Access Compliance Report

Public Rights-of-Way

Intersection ID: 29125	Main Street: ALDERPOINT_LN	Cross Street: APPLIEDALE_DR	Location: E
ADA ID: E946A24FD7B9	Ramp Type: BlendTrans1	Initial Pass/Fail: Fail	Overall Compliance: No
		Severity Score: 1.25

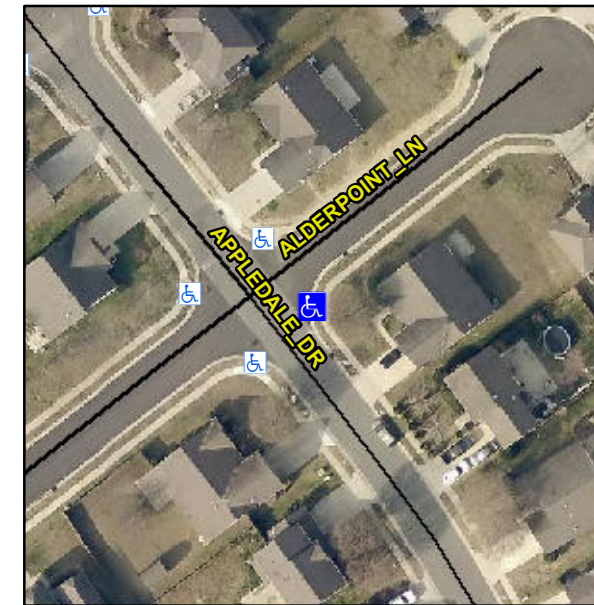
Not Found, R304.5.3

Compliance	Description	Data	Compliance	Description	Data
N/A	Ramp Length (in)	39.5	Yes	BlendTrans Slope (%)	3.8
Yes	Ramp Width (in)	132.0	No	BlendTrans XSlope (%)	2.3
N/A	Flare Type LT	N/A	N/A	Flare Type RT	N/A
N/A	Flare Slope LT (%)	N/A	N/A	Flare Slope RT (%)	N/A
N/A	Flare Traversable LT?	N/A	N/A	Flare Traversable RT?	N/A
N/A	Landing Length (in)	N/A	N/A	DWS Provided?	N/A
N/A	Landing Width (in)	N/A	N/A	DWS Contrast?	N/A
N/A	Landing Slope (%)	N/A	N/A	DWS Length (in)	N/A
N/A	Landing X Slope (%)	N/A	N/A	DWS Full Width?	N/A
N/A	Landing Curb? (Y/N)	N/A	N/A	DWS Offset (in)	N/A
N/A	Shared Landing?	N/A			
N/A	Gutter Ponding?	N/A	N/A	Gutter Slope (%)	N/A
N/A	Gutter Lip Ht (in)	N/A	N/A	Gutter X Slope (%)	N/A
N/A	Painted X Walk1?	No	N/A	Painted X Walk2?	No
	X Walk 1 Direction	To NW		X Walk 2 Direction	To SW
	X Walk 1 Width (in)	N/A		X Walk 2 Width (in)	N/A
	X Walk 1 Slope (%)	1.3		X Walk 2 Slope (%)	1.7
	X Walk 1 X Slope (%)	1.9		X Walk 2 X Slope (%)	1.4

N/A	Ramp inside XWalk1?	N/A	N/A	Ramp inside XWalk2?	N/A
	Road Slope (%)	2.3		Clear Space?	N/A
	Road X Slope (%)	0.2	N/A	Clear Space to XWalk (in)	N/A
N/A	Any Obstructions?	N/A	N/A	Storm Grate/Utility Hazard?	N/A
	Obstruction Type			Storm Grate/Utility Type	
		N/A			N/A
			Yes	Surface Condition? (G/P)	Good
			No	Curb Slope (%)	18.7

Remove & Replace Curb Ramp With Two New Directional Ramps or Equivalent.
